Hope Creek Generating Station
Facility Operating License No. NPF-57
NRC Docket No. 50-354

Subject: Response to Request for Additional Information
Request for License Amendment - Extended Power Uprate

Extended Power Uprate Response to Request for Additional Information

Figure RAI14.79.1. Substructure of a steam dryer used for mesh convergence tests. Blue lines indicate cantilevered support, red lines denote free edges, and black lines show connections between parts.

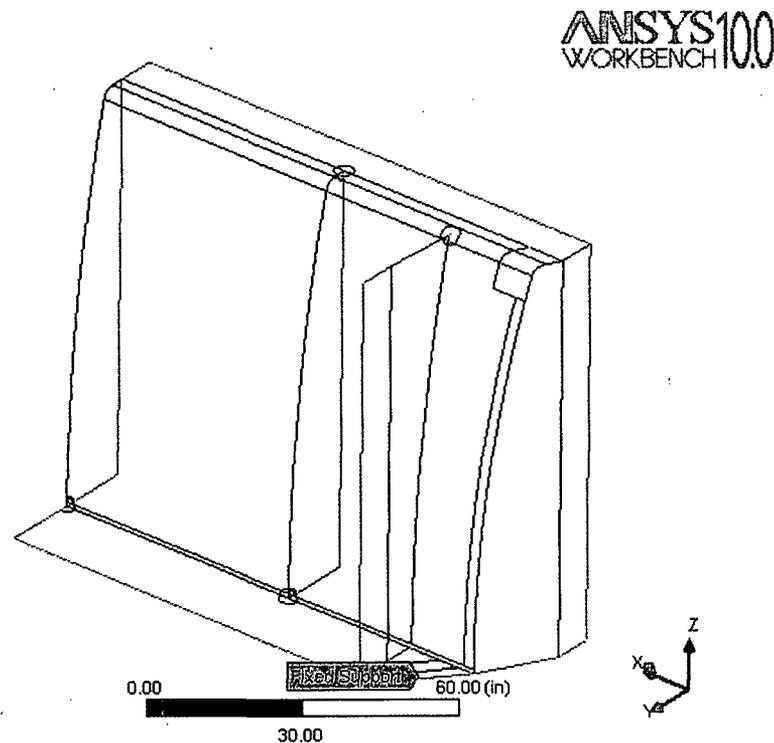
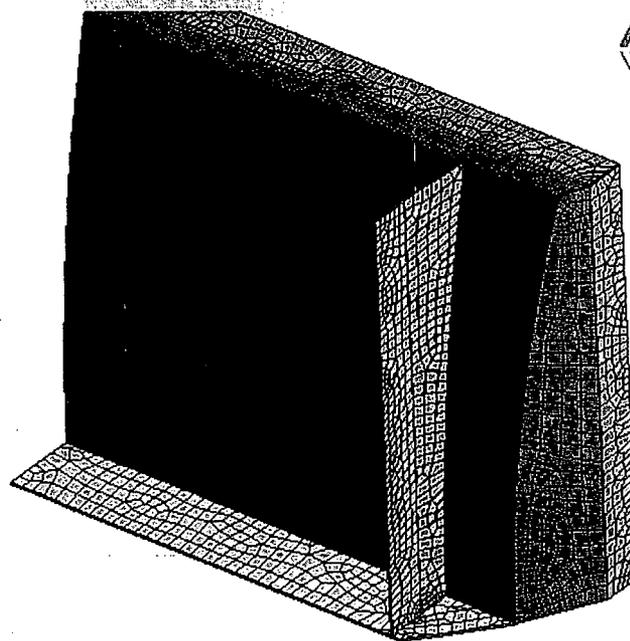
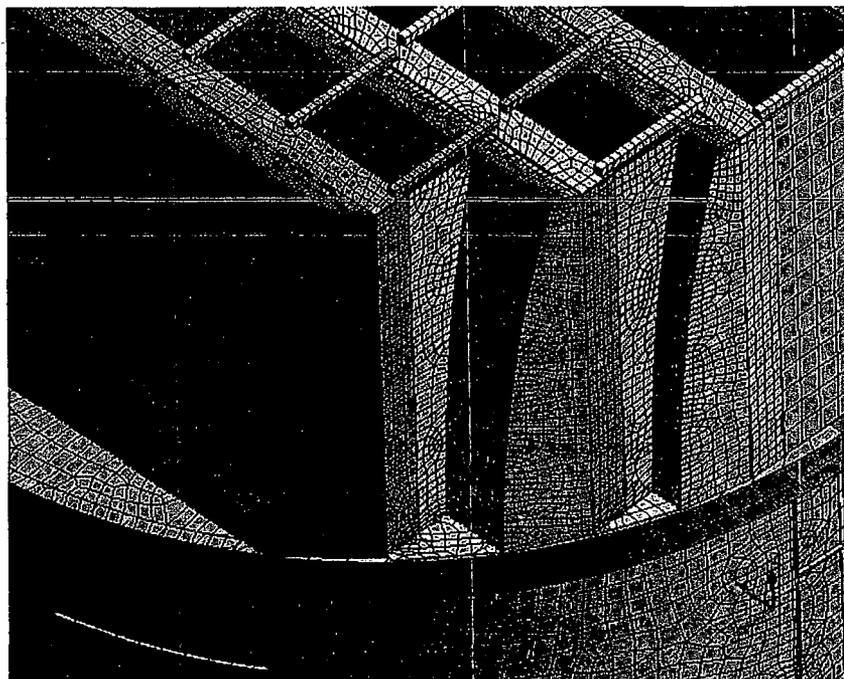
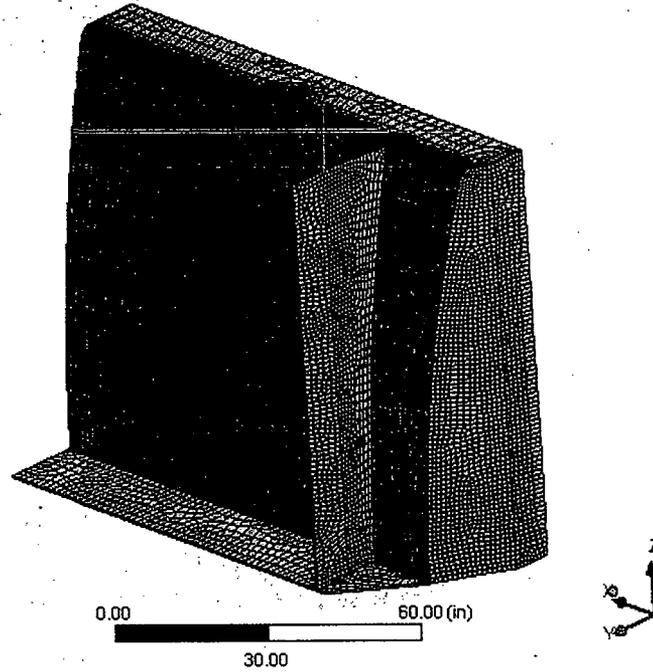
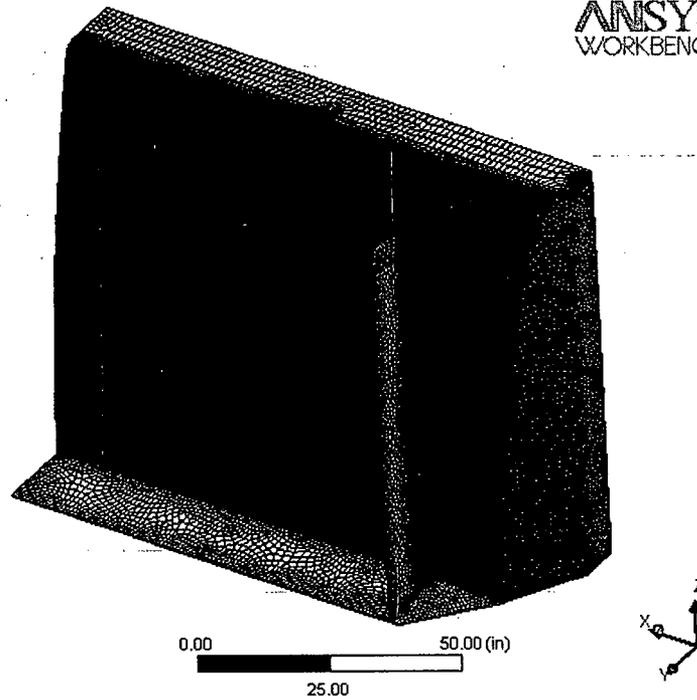
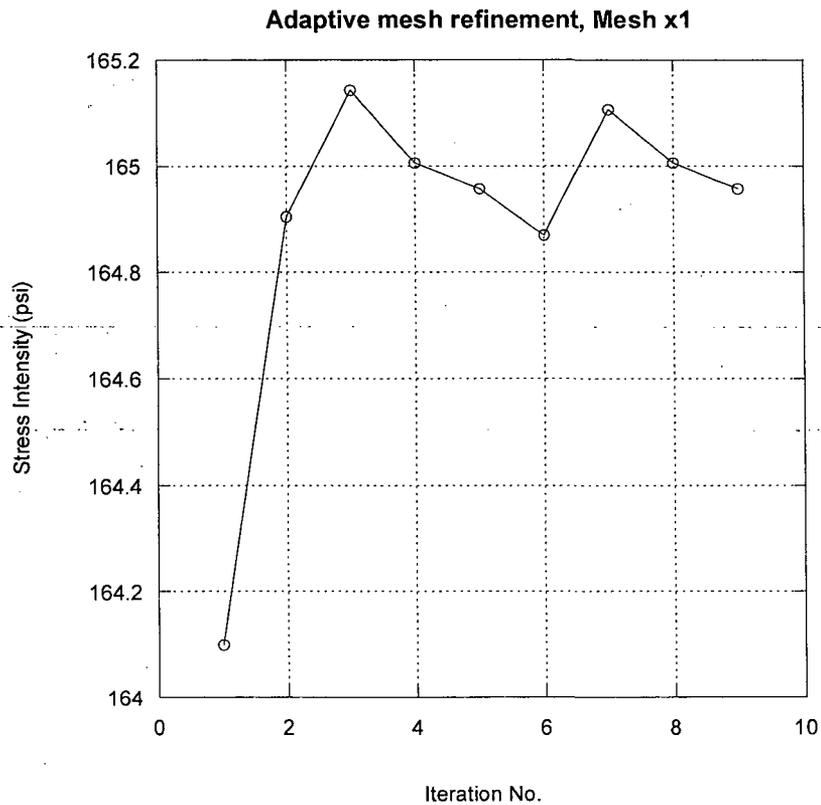
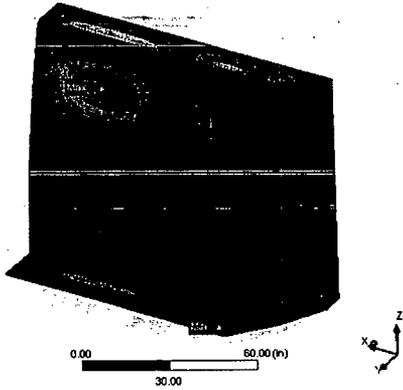
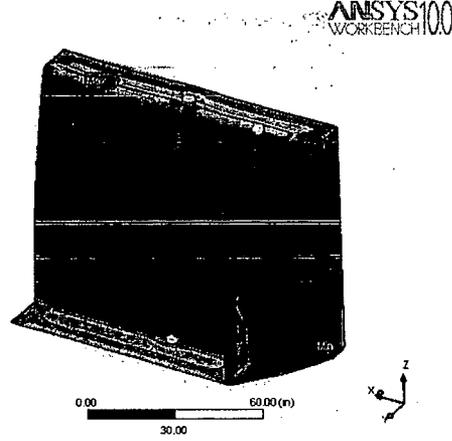
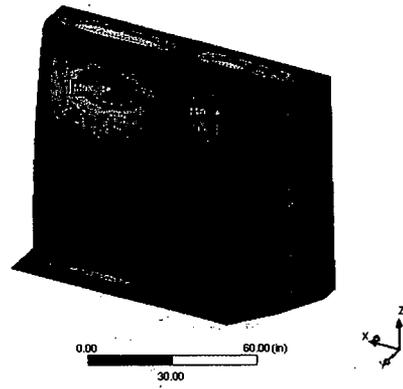
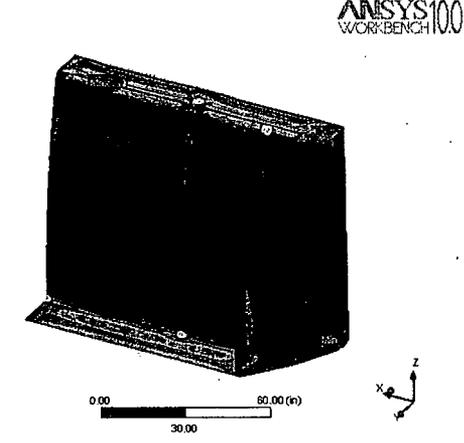
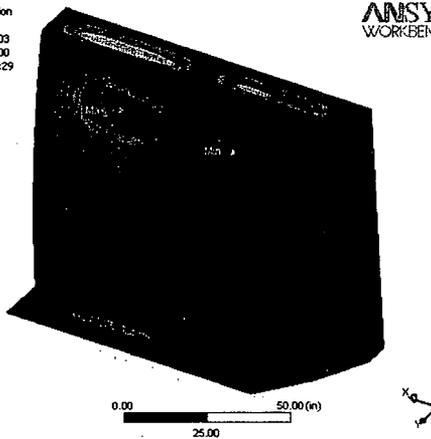
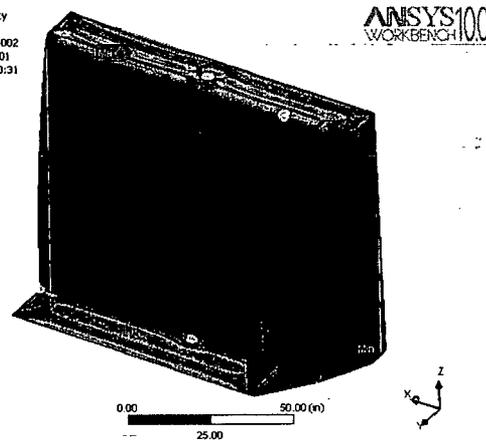
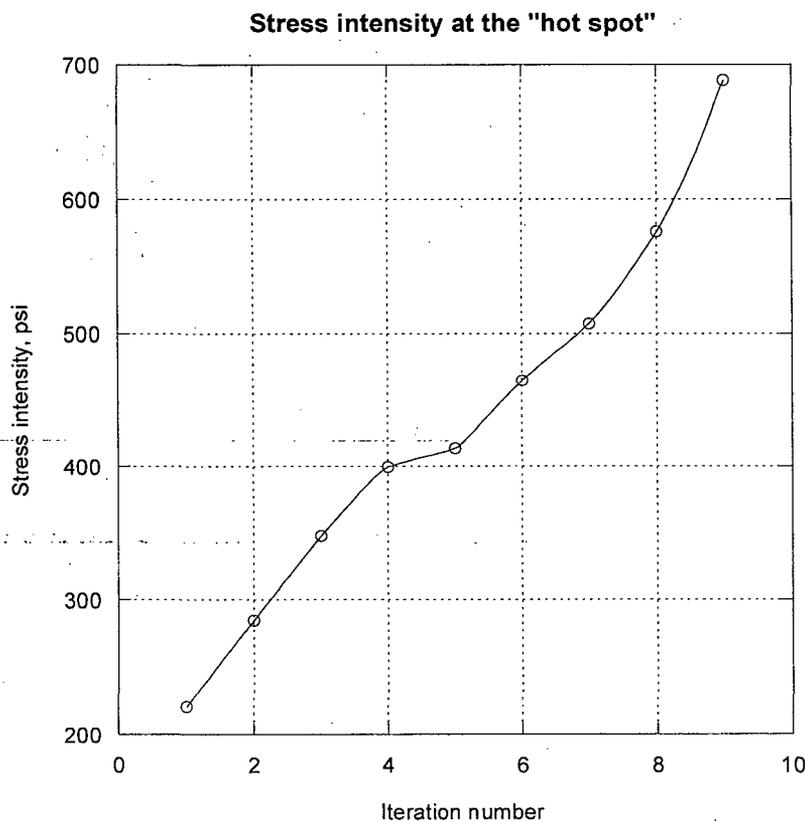
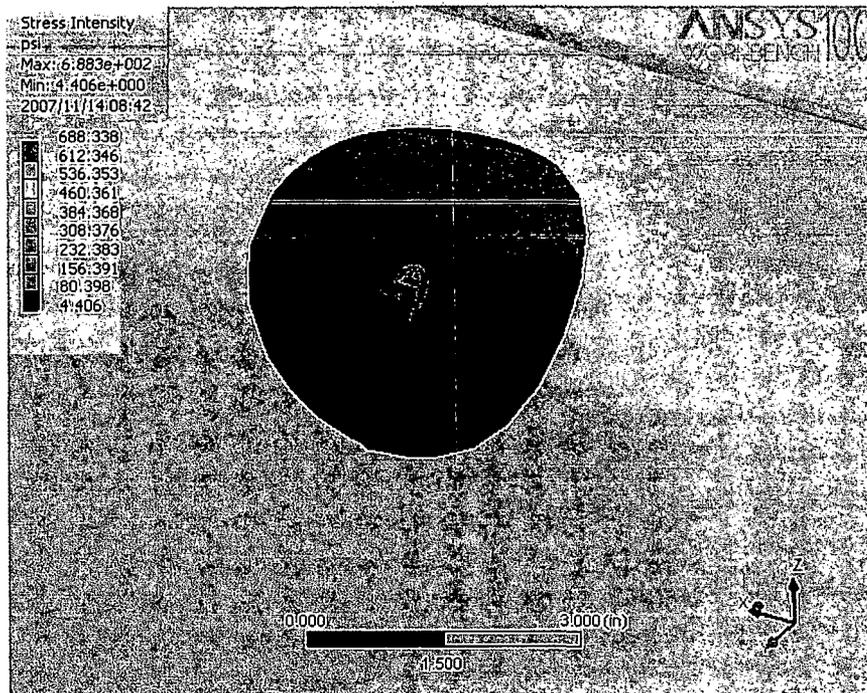
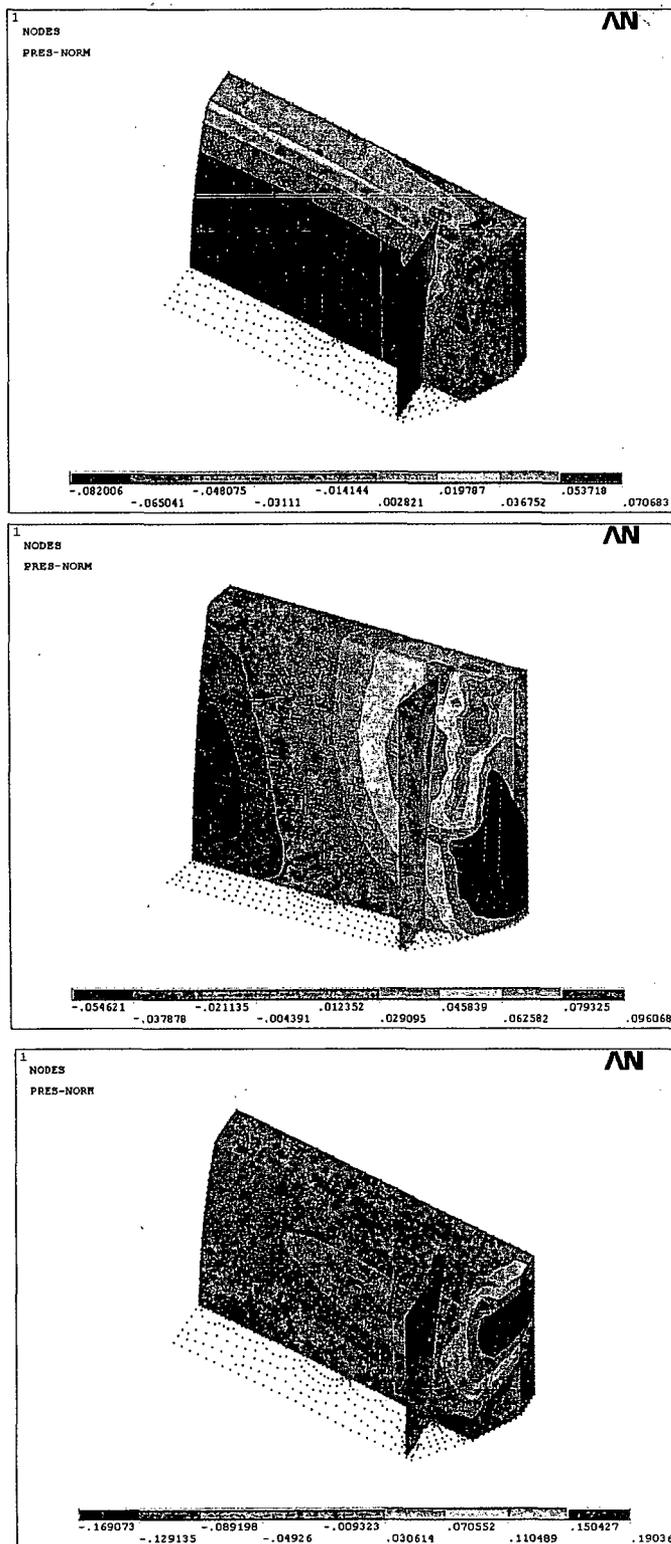
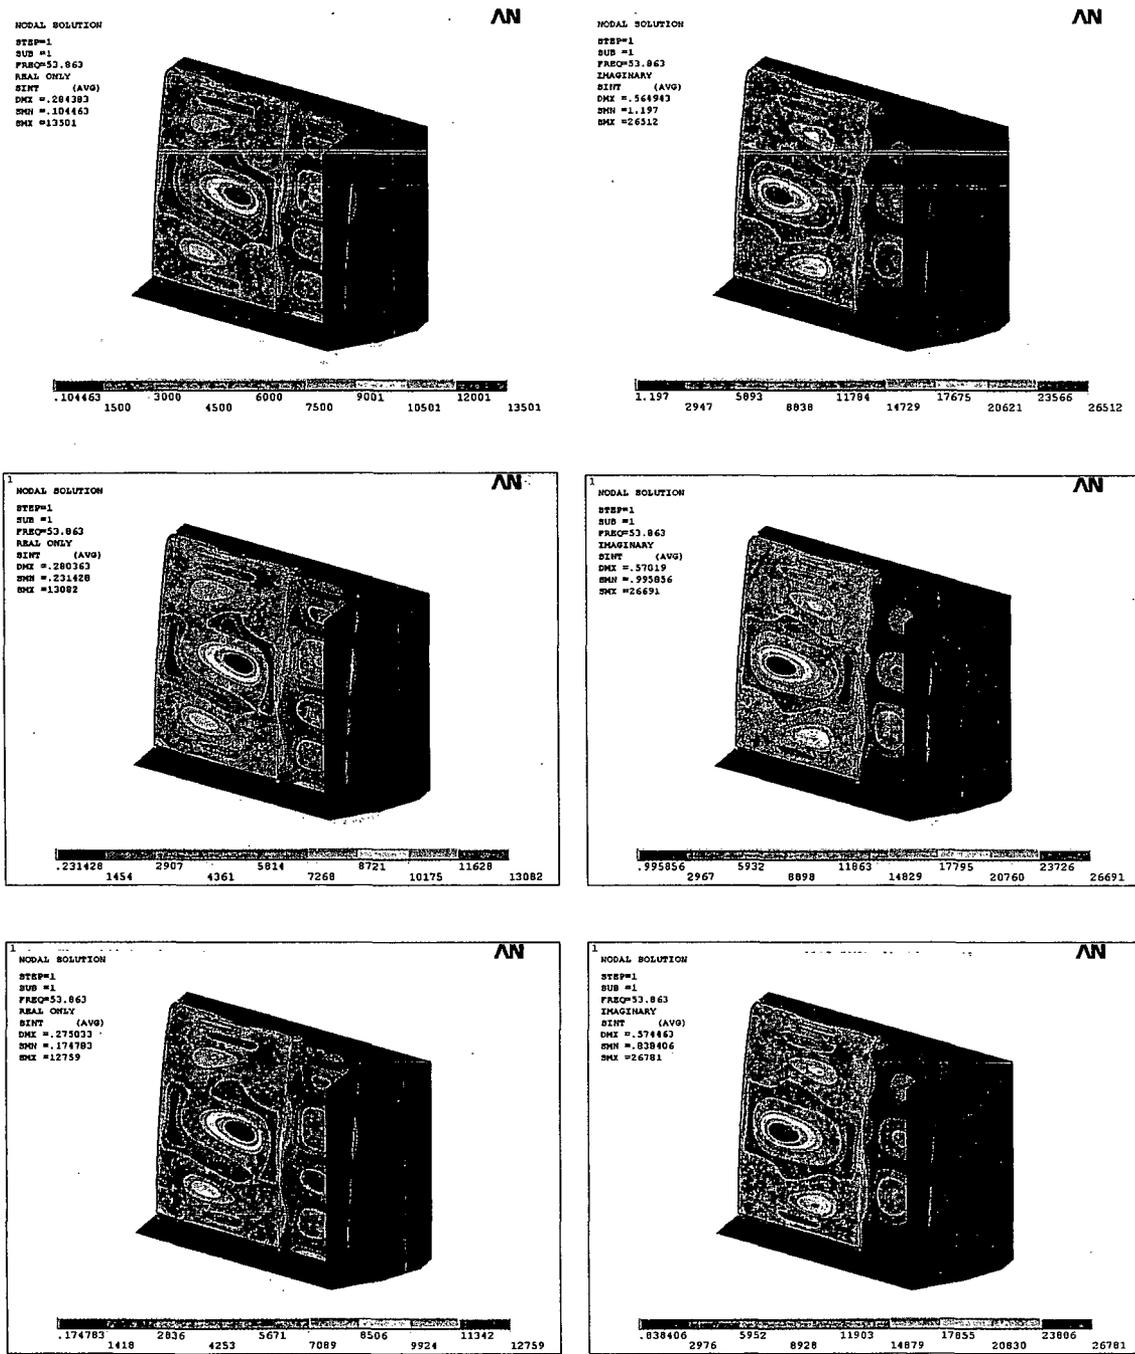
In response to RAI 14.79 and in Section 3.8, *Mesh Details and Element Types*, of CDI Report No. 07-17P, PSEG describes numerical experiments carried out using the ANSYS code applied to simple analytically tractable structures with dimensions and mesh spacing similar to the ones used for the steam dryer, confirming that the natural frequencies are accurately recovered (less than 1 percent errors for the first modes). The staff noted that establishing convergence of resonance frequencies is not sufficient to establish convergence of strain and stress fields. Also, frequency shifting loading functions does not account for lack of convergence in strain and stress fields. Therefore, as a follow-up to RAI 14.79, PSEG is requested to provide pertinent parametric evaluations related to mesh convergence in high strain and stress regions in the Hope Creek steam dryer to assess whether the dimensions and mesh spacing used for the model are adequate. In particular, plots of stresses near high stress regions for coarse and dense FE meshes could be used to confirm that the dryer model used to establish the Hope Creek limit curves are converged.

Mesh refinement tests were conducted on a structure excised from the Hope Creek Unit 1 steam dryer comprising the middle hood with two hood supports, side plate, cover plates and closure plate as shown in Figure RAI14.79.1. All dimensions and structural properties were kept the same as in the full model. Structural damping was prescribed at 1% of critical at all frequencies. Cantilevered supports were introduced at the edges typically coupled to heavier parts of the steam dryer such as the upper support ring and vane bank.

To investigate the mesh dependence of stresses and displacements, three different grids were considered. The coarsest mesh, labeled Mesh x1, is representative of the mesh sizing used in the full steam dryer calculation (see top figure of Figure RAI14.79.2a) and contains 4329 nodes and 4208 elements. A finer mesh, denoted by Mesh x2 and containing 11914 nodes and 11726 elements, is obtained by uniformly

The typical convergence behavior for the maximum stress intensity during adaptive mesh refinement is shown in Figure RAI14.79.3, where the horizontal scale ("Iteration Number") is the number of adaptive mesh refinement steps. The results of adaptive refinement for all three initial grids are summarized in Table RAI14.79.1. The calculated stresses did not change appreciably during adaptive local mesh refinement. Overall, the range of computed stress intensity values is within 4% of stress intensity values computed on Mesh x1. The deflected shapes and stress intensity distributions are shown in Figure RAI14.79.4. These results show that the static solution is indeed satisfactorily converged on the grid Mesh x1.

To investigate the reason for this discrepancy, additional calculations were undertaken over the 100 – 102 Hz frequency range in 0.25 Hz increments, and the amplitude at Location 2 was computed. The results are summarized in Figure RAI14.79.9 and show that at 101.4 Hz the frequency response is changing rapidly and that the 15.8% variation can be attributed to the slight shift in the frequency response on different meshes. Thus, rather than comparing the stress intensities at a fixed frequency, it is more useful to compare the maximum stress intensity amplitudes on each mesh. This comprises a more relevant comparison, since these maxima in the stress intensity frequency responses correspond directly to the values tabulated in the full steam dryer stress reports (and, consequently, also the stress ratios). From Figure RAI14.79.9, the peak response on all meshes occurs at 100.75 Hz. The associated peak stress amplitudes are plotted versus mesh size in Figure RAI14.79.10. The actual values are 3510.4 psi on Mesh x1, 3688.5 psi on Mesh x2, and 3790.8 psi on Mesh x4. In Figure RAI14.79.10 the mesh size is normalized by the average element size of Mesh x1; hence the normalized mesh sizes of Mesh x1, Mesh x2, and Mesh x3 are 1.0, 0.5, and 0.25, respectively. It may be seen that computed peak stresses adhere closely to a linear dependence on mesh size. Therefore, one can fit the available values and reliably extrapolate to estimate the stress peak at infinite mesh resolution (i.e., mesh size = 0). From the equation of the linear fit, shown on Figure RAI14.79.10, the best estimate of stress intensity at the peak is 3880 psi. This implies that the error in the coarsest Mesh x1 peak stress prediction (of 3510.4 psi) is $(3510.4 - 3880.0)/3880.0 = 9.53\%$.

In conclusion, a grid with element size typical of Mesh x1, which is representative of that used in the full steam dryer evaluation, incurs errors in the peak stresses that are less than 10%.
